# SERVICE INFORMATION LETTER

**Subject:** IGVA Sector Gear with Oversize D-Hole Creating Loose Fit with NHA

**Figure 1, Sector Gear, Showing Oversize D-Shaped Hole**

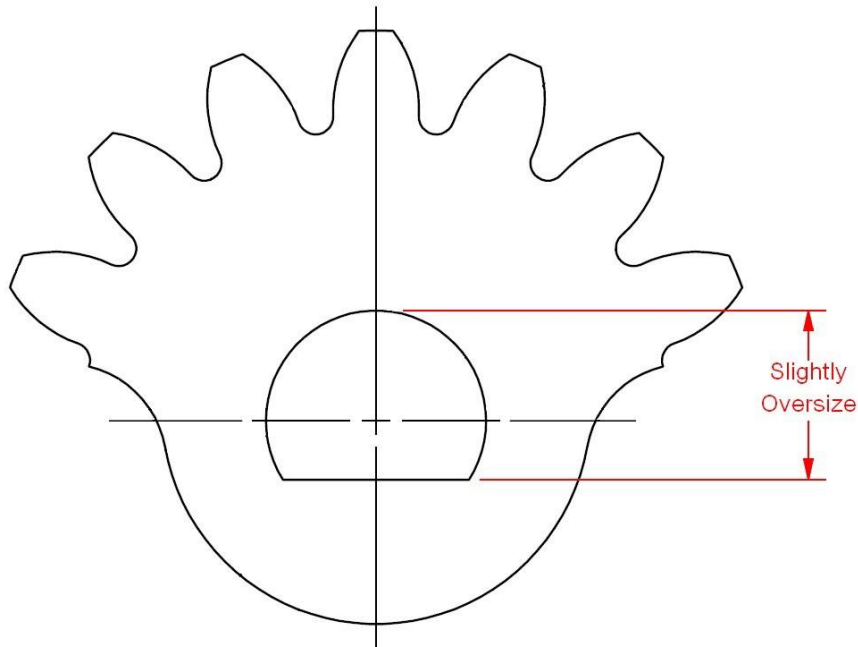
The D-shaped hole in the Wencor Inlet Guide Vane Assembly Sector Gear PN 3810119-2WE was manufactured oversize by .002” as shown below in Figure 1. The oversize condition will create a loose fit with the mating part and may lead to premature wear on the Inlet Guide Vane (IGV) stem, or other IGVA parts that operate in conjunction with the Sector Gear (see Figure 2).

Based upon a customer report of a tight installation problem, Wencor revised the Sector Gear design by adjusting the maximum D-shaped hole size up by .002" to prevent a possible interference condition with the mating IGV Vane stem. It was later discovered that the IGV Vane stem was the cause of the interference condition and the D-shaped hole size was re-designed larger than allowed per the OEM CMM. The re-designed Sector Gears were sold to customers and put into service.

The size of the Wencor Sector Gear D-shaped hole has subsequently been revised and is now equivalent to the OEM hole size limits. All Wencor Sector Gears purchased after July 2012 have the correct D-shaped hole size.

For new Wencor Sector Gears that have not been installed, users can verify correct D-shaped hole size by measuring the hole as described in the OEM Component Maintenance Manual (CMM). Any Wencor Sector Gear D-shaped hole that is measured oversize shall be returned to Wencor for replacement.

For Wencor Sector Gears that have been installed, the user shall check the size of the D-shaped hole at the next shop maintenance/overhaul opportunity. Any Wencor Sector Gears that are within CMM limits can remain in service and any that are out of limits shall be removed and replaced according to the CMM.
